**Released Engineering Change Notice**

Product	ZED 1402
---------	----------

Title	Distribution Chassis Gnd to Earth Stud
-------	--

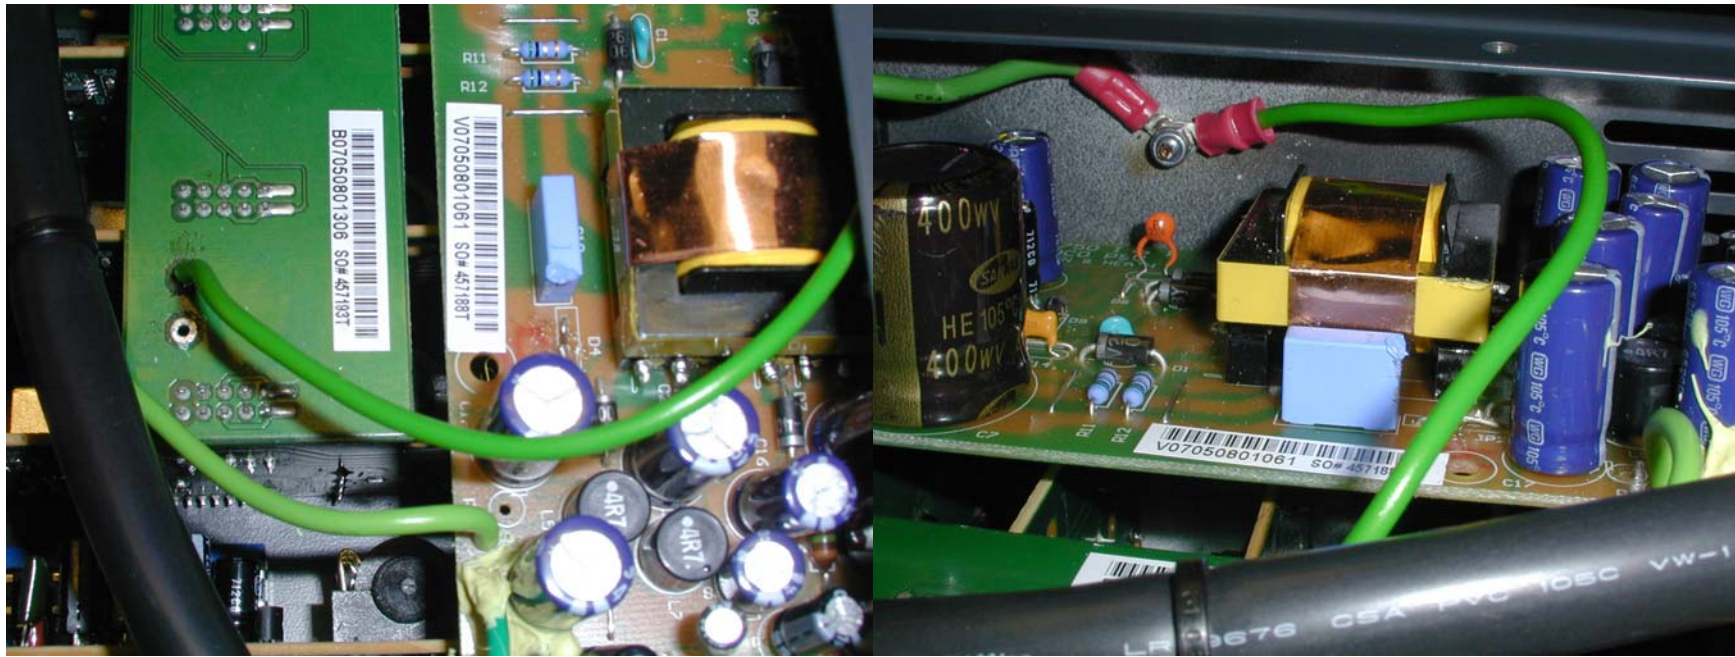
Details Of Change
Additional chassis grounding.

Reason for change
Units with USB pcb Issue 2 exhibit some noise variations with different laptops

Additional Information
Fit 15cm AH0025 *WIRE 16/0.2 PVC GREEN TRI-RATED plus AL3449 CRIMP TERM RING 4BA INSUL, from 003-658 PCB ASSY ZED 14 DISTRIBUTION AG6749 (P3), to internal chassis earth stud. See photos.
